Service Bulletin No: 21-006

Modification No: EC-14-0379

AIR CONDITIONING - DISTRIBUTION**INSPECT, AND IF NECESSARY, REPLACE THE AIR CONDITIONING HOSES IN THE DE-FOG SYSTEM****1. Planning Information****A. Effectivity**

Inspection and, If Necessary, Replacement of the ECS Hose in the Cockpit (Config 1 Aircraft)
Figure 1

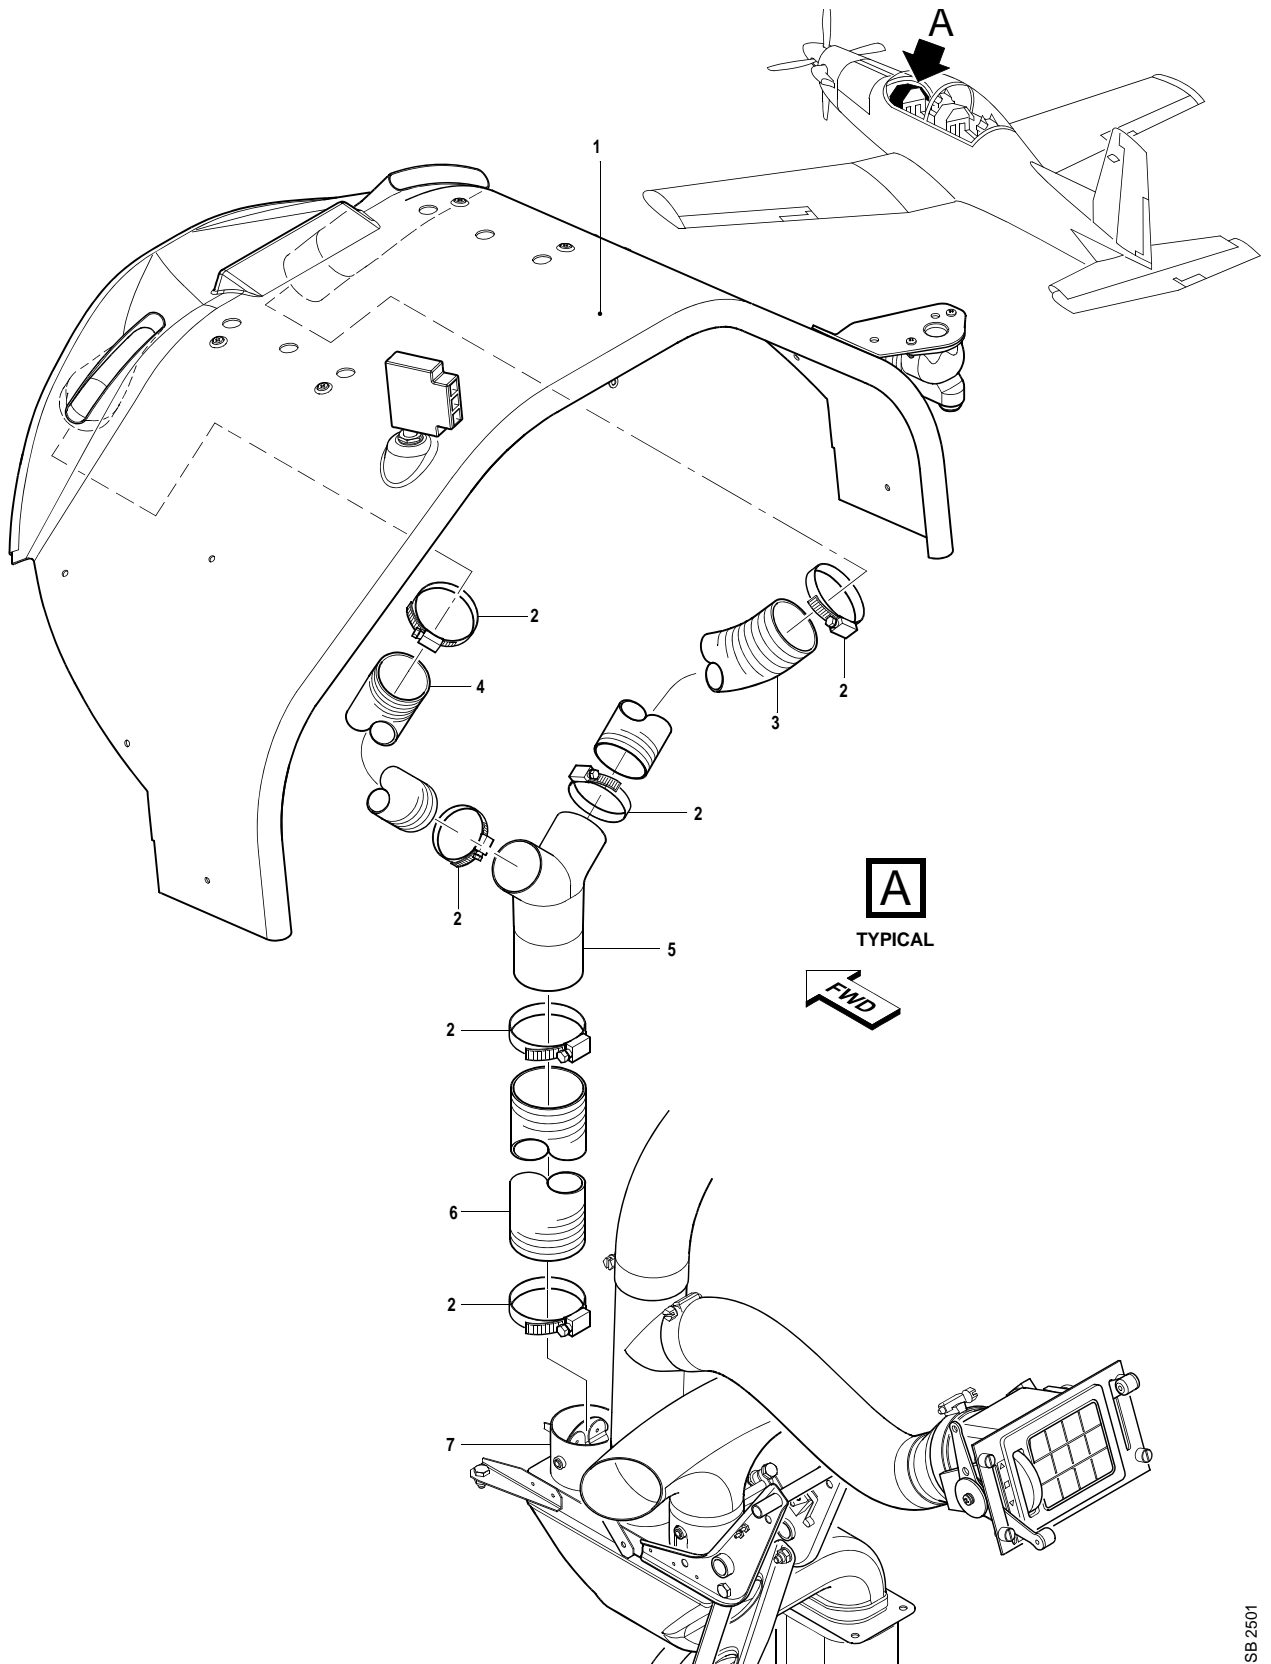
(1) **For Config 1 Aircraft (Ref. Fig. 1 and Fig. 3)**

- (a) Do an inspection of the ECS hose (3) in the front cockpit (Ref. Fig. 1).
- (b) Do an inspection of the ECS hose (2) in the engine compartment (Ref. Fig. 3).
- (c) If the hoses are dark grey in color, they are type 984 and must be replaced.
- (d) Replace the ECS hoses:

1 Remove the ECS hose in the front cockpit (Ref. Fig. 1):

- a Remove the front coaming (1) (Ref. AMM, 34-13-02 or 34-13-03, Page Block 401 for more information).
- b Loosen the clamp (2) that attaches the air hose (3) to the front distribution unit (4).

- d Remove the air hose (3).
 - e Remove and keep the clamps (2) from the air hose (3).
 - f Discard the air hose (3).
- 2 Install the new hose in the front cockpit (Ref. Fig. 1):
- a Put the clamps (2) on the new air hose (3) (P/N 917.96.83.057).
 - b Put the new air hose (3) (P/N 917.96.83.057) in position:
 - c Put the lower clamp (2) in the correct position on the new air hose (3) (P/N 917.96.83.057) and tighten.

NOTE: Do not tighten the upper clamp (2) that attaches the new air hose (3) (P/N 917.96.83.057) to the front coaming (1). This is done during the front coaming installation (Ref. Step 3.B.(1)(d)2d).

- d Install the front coaming (1) (Ref. AMM, 34-13-02 or 34-13-03, Page Block 401 for more information).
- 3 Remove the ECS flexible pipe in the engine compartment (Ref. Fig. 3):
- a Loosen the clamps (1) that attach the flexible pipe (2) to the fresh air inlet (3) and the mount (4) on FR1.
 - b Remove the flexible pipe (2) and the clamps (1).
 - c Remove and keep the clamps (1).
 - d Discard flexible pipe (2).
- 4 Install the new flexible pipe (Ref. Fig. 3):
- a Put the clamps (1) on the new flexible pipe (2) (P/N 917.96.83.001).
 - b Put the new flexible pipe (2) (P/N 917.96.83.001) in position.
 - c Put the clamps (1) in the correct position on the new flexible pipe (2) (P/N 917.96.83.001) and tighten.

Inspection and, If Necessary, Replacement of the ECS Hoses in the Cockpit (Config 2 Aircraft)
Figure 2

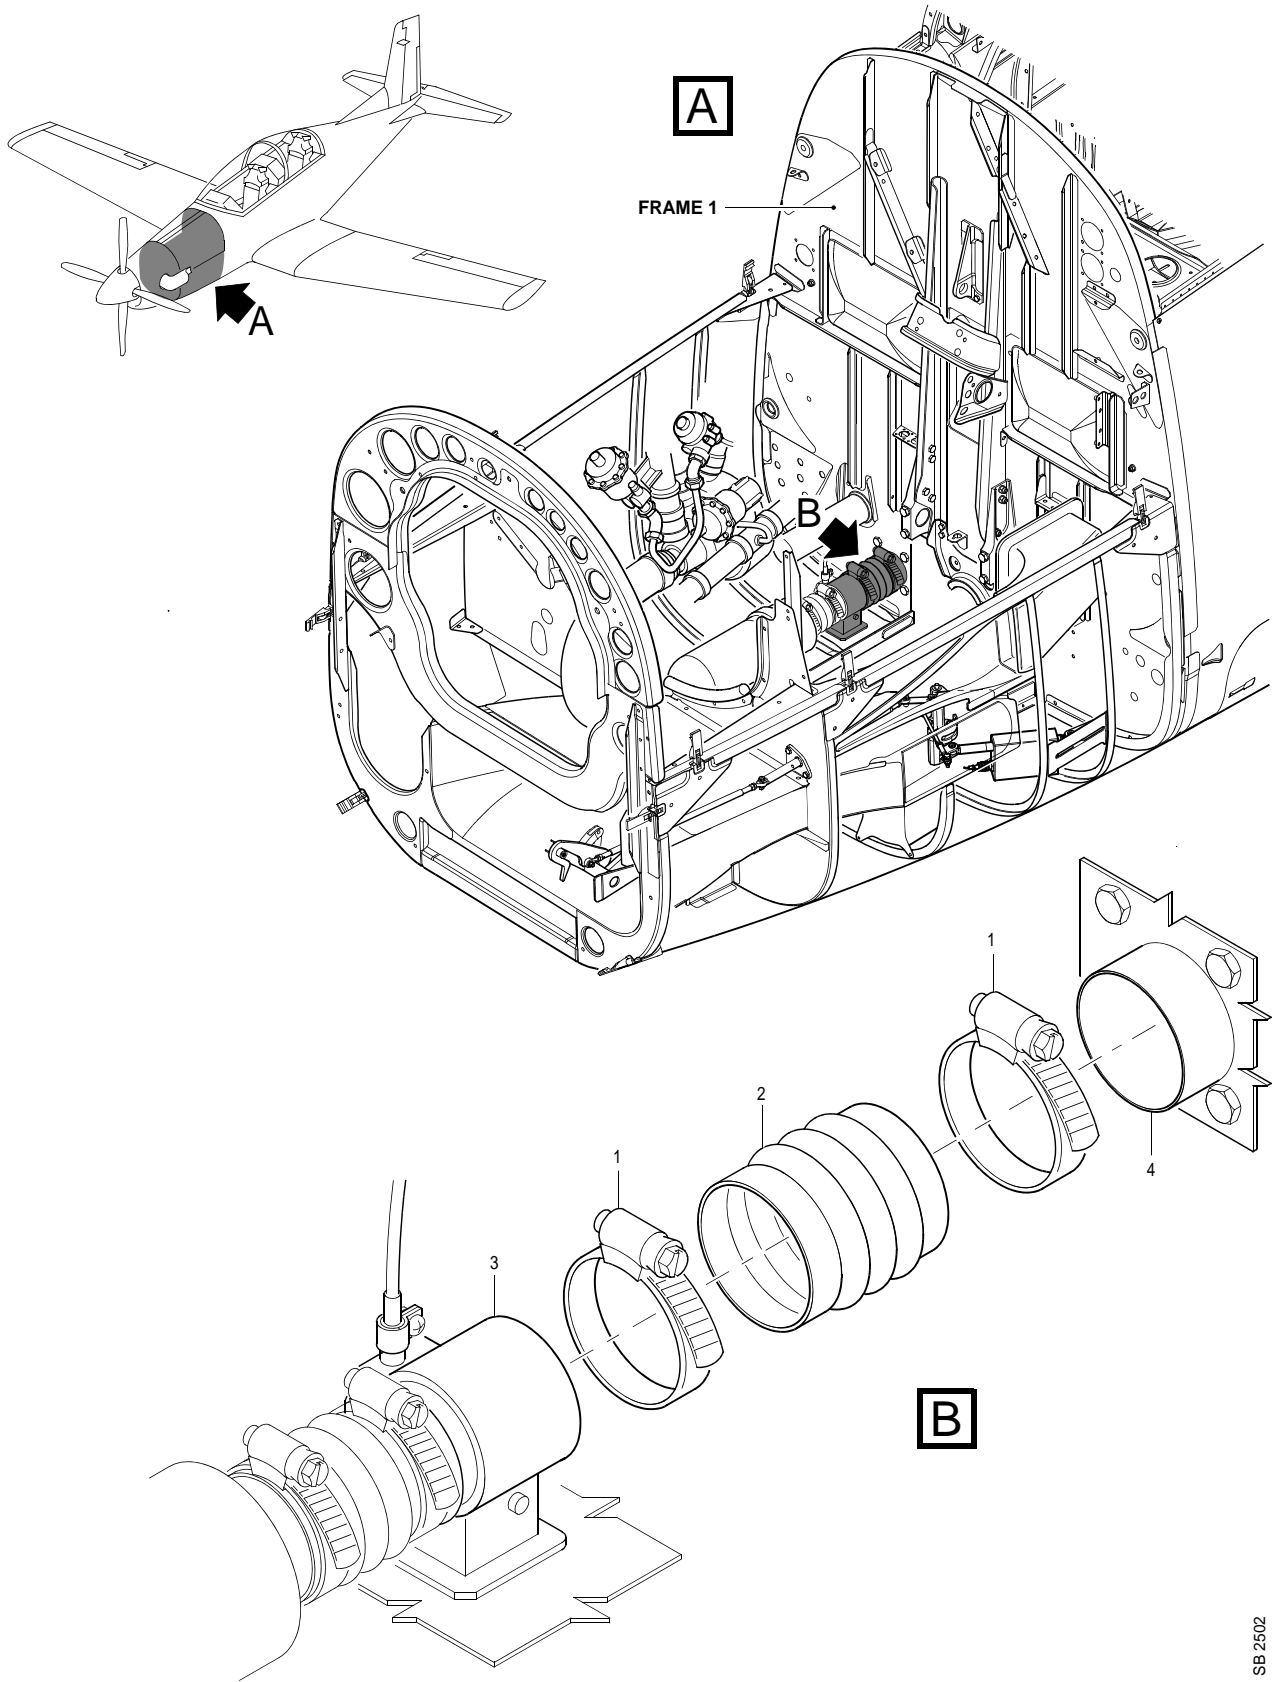
(2) For Config 2 Aircraft (Ref. Fig. 2 and Fig. 3)

- (a) Do an inspection of the ECS hoses (3), (4) and (6) in the front cockpit (Ref. Fig. 2).
- (b) Do an inspection of the ECS hose (2) in the engine compartment (Ref. Fig. 3).
- (c) If the hoses are dark grey in color, they are type 984 and must be replaced.

1 Remove the ECS hoses in the front cockpit (Ref. Fig. 2):

- a Remove the front coaming (1) (Ref. AMM, 34-13-02 or 34-13-03, Page Block 401 for more information).
- b Loosen the clamps (2) that attach:
- The air hose (4) to the air duct (5)
 - The air hose (3) to the air duct (5)
 - The air hose (6) to the front air distribution unit (7) and the air duct (5).

- c Move the clamps (2) to the center of the air hoses (3), (4) and (6).
- d Remove the air hoses (3), (4) and (6).
- e Remove and keep the clamps (2) from the air hoses (3), (4) and (6).
- f Discard the air hoses (3), (4) and (6).

2 Install the new hoses in the front cockpit (Ref. Fig. 2):

- a Put the clamps (2) on:
- The new air hose (6) (P/N 917.96.83.055)
 - The new air hose (4) (P/N 917.96.83.053)
 - The new air hose (3) (P/N 917.96.83.053).
- b Put these hoses in position:
- The new air hose (6) (P/N 917.96.83.055)
 - The new air hose (4) (P/N 917.96.83.053)
 - The new air hose (3) (P/N 917.96.83.053).

- c Put the clamps (2) in the correct position on:
- The new air hose (6) (P/N 917.96.83.055)
 - The new air hose (4) (P/N 917.96.83.053)
 - The new air hose (3) (P/N 917.96.83.053).

NOTE: Do not tighten the clamps (2) that attach the air hoses (3 and 4) to the front coaming (1). This is done during the front coaming installation (Ref. Step 3.B.(2)(d)2d).

Inspection and, If Necessary, Replacement of the ECS Hoses in the Engine Bay (Config 1 and 2 Aircraft)
Figure 3

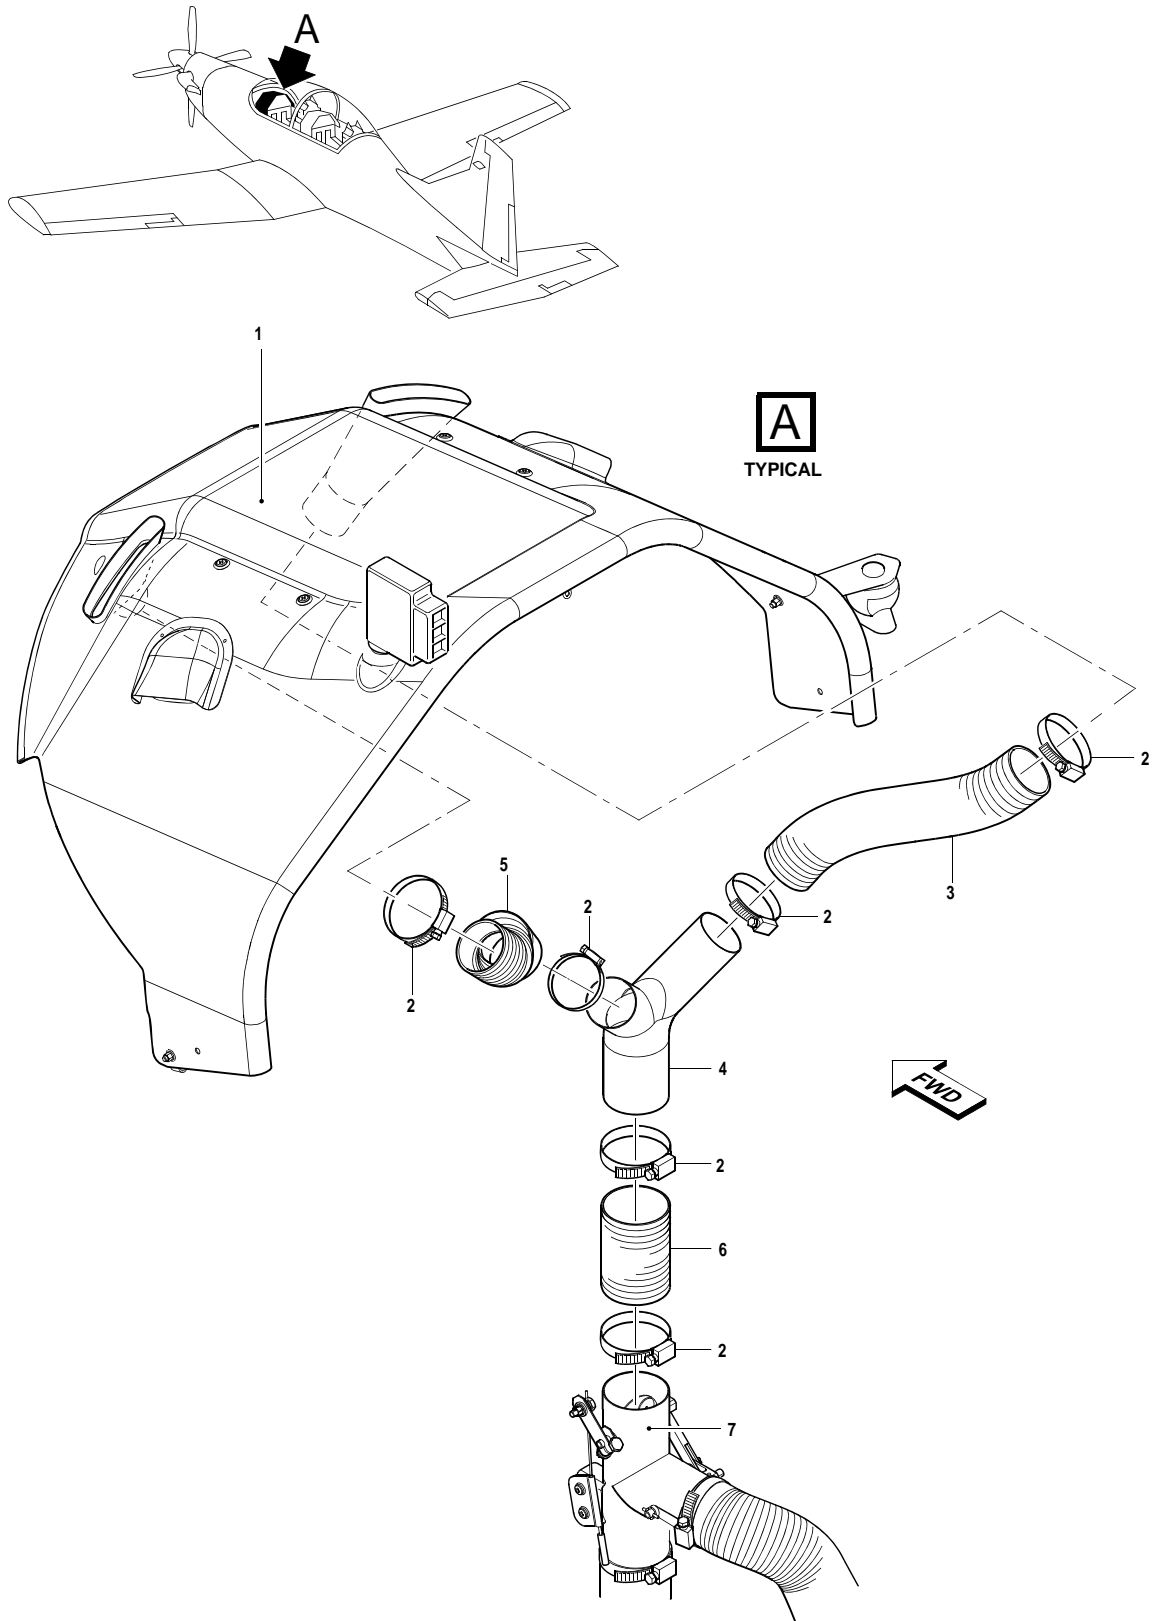
- 3 Remove the ECS flexible pipe in the engine compartment (Ref. Fig. 3):

- a Loosen the clamps (1) that attach the flexible pipe (2) to the fresh air inlet (3) and the mount (4) on FR1.
- b Remove the flexible pipe (2) and the clamps (1).
- c Remove and keep the clamps (1).
- d Discard flexible pipe (2).

- 4 Install the new flexible pipe (Ref. Fig. 3):

- a Put the clamps (1) on the new flexible pipe (2) (P/N 917.96.83.001).
- b Put the new flexible pipe (2) (P/N 917.96.83.001) in position.
- c Put the clamps (1) in the correct position on the new flexible pipe (2) (P/N 917.96.83.001) and tighten.
